Editorial Modifications to the Safety Analysis Report, for the RT-100, Rev 2

RT-100 Type B Cask
RAI Responses
Docket Number 71-9365
TAC Number L24686
September 18, 2013

The NRC Request for Additional Information (RAI) identifies information needed by the staff in connection with its review of the Robatel Safety Analysis Report, Revision No. 1, dated November 30, 2012. The RAI comments are grouped by chapter number and title from the Safety Analysis Report, along with the Robatel response. The response addresses the comment and where applicable, references the locations in the SAR and/or supporting documents where revised information can be located.

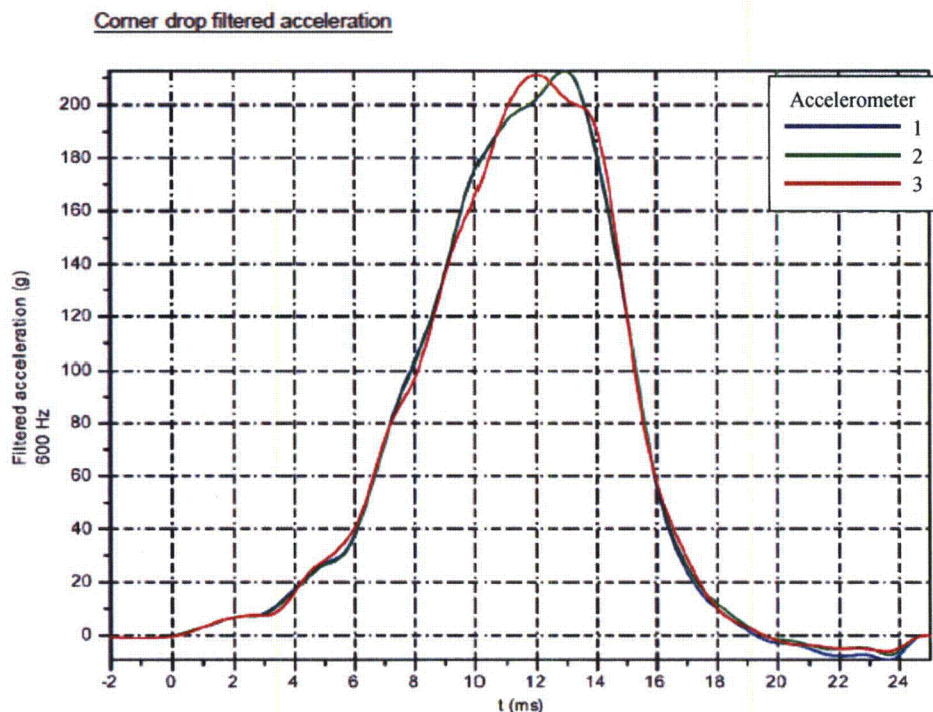
Provide further justification that explains how and why the foam crush strength data, in the “densification region” for strains beyond 60%, is used. This is a follow-up to RSI 2.2. Explain how lock-up is considered and evaluated in the analysis.

In response to RSI 2.2, the applicant indicated that the extrapolated values used are considered to be conservative and yielded a conservative deceleration value when compared to the drop test results. In addition to this justification, also provide an explanation of why a deviation from the manufacturer’s recommended properties is required and appropriate. This deviation may be important in the analytical effort that considers variations in the package design that were not present in the scale model drop test.

The analytical approach used extrapolation values past 60% strain in the foam. The accelerations and crush was bench marked with actual scale model drop testing. The calculation results always bound the drop test results. There is no lock up even above 60% compression of the foam.

The foam densities are held to a tighter tolerance than the manufacturer's recommended values to allow the size of the impact limiter to be optimized given the oversize dimensional restrictions and the size of the cask body. The deviation from the manufacturer's recommended properties is appropriate due to the fact that the foam is poured under controlled conditions rather than injected as is typically performed for impact limiters. The supplier was consulted and is in agreement with these tolerances. The supplier is required to provide density testing results confirming that the material is within the acceptable tolerance range.

Figure 2-15.1 3/10th Scale Corner Drop Accelerations

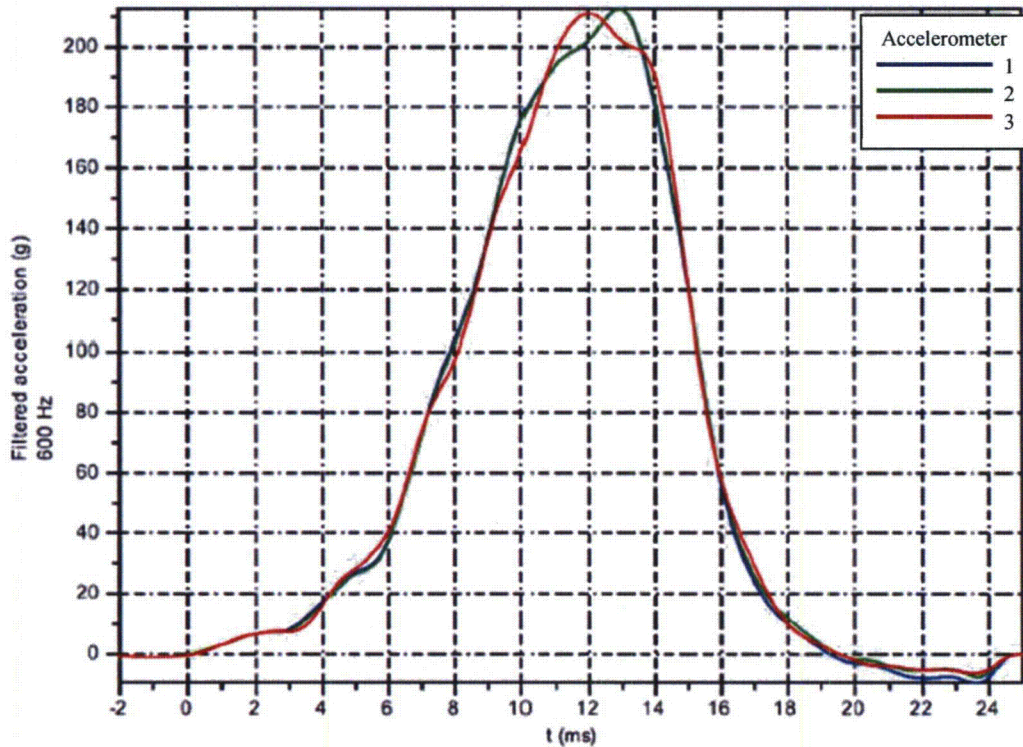
The applicant claims, in Section 2.7.1.3, that the 9m end and side drop HAC tests bound the 9m corner drop test. Appendix 2.13.3.4.1 of the application develops the impact limiter time history response for the 9m HAC corner drop case, and the impact limiter methodology was verified in Section 2.13.4.1 against a scaled NUPAC-125B package (Single Foam - Series FR3700 with a density of 12 pcf). However, the construction of the Model No. RT-100 package impact limiter design is fundamentally different from the NUPAC-125B design.

Per Table 2.13.4.2.1.3-2, the calculated crush depth is 534mm whereas the maximum crush depth is 544mm, which gives only a 10 mm margin. Also, Appendix F of the RT-100 3/10 scale drop test report, referenced 102885 RES 001, does not provide a final impact limiter crush depth for the corner drop. See also RAI 2-17.

The analytical prediction of the deceleration and the maximum crush depths were confirmed by comparison to the 3/10th scale model drop test results. Table 2-15.1 (shown below) provides a comparison of the 3/10th scale drop test results and the analytical method predictions. The data presented in Table 2-15.1 (shown below) is presented in the revised SAR. For this comparison, the analytical predictions for both the static and dynamic foam properties at the drop test temperature are provided. As Table 2-15.1 (shown below) shows, the maximum crush depth for the scale model using the analytical method is 157.1 mm as compared to the drop test result of 140.8 mm. This represents an additional crush capacity of 16.3 mm. Scaling the 3/10-scale model deformation to full-sized would result in a crush depth of 469.3 mm. Comparing the full scale analytical corner drop prediction of 544 mm results in an additional capacity of 74.7 mm. Therefore, the results indicate the analytical prediction over predicts the accelerations and crush when compared to the 3/10th scale test results. Additionally, the test shows that there is sufficient capacity to protect the cask during the corner drop event. Chapter 2, Appendix 2.12, Section 2.12.5 of the SAR is revised to present the comparison of analytical and scale model test results.

the inner lid. The minimum margin of safety is found to be +1.0 for primary membrane plus bending stress intensity. Chapter 2, Section 2.7.1.3 of the SAR has been revised to include this information.
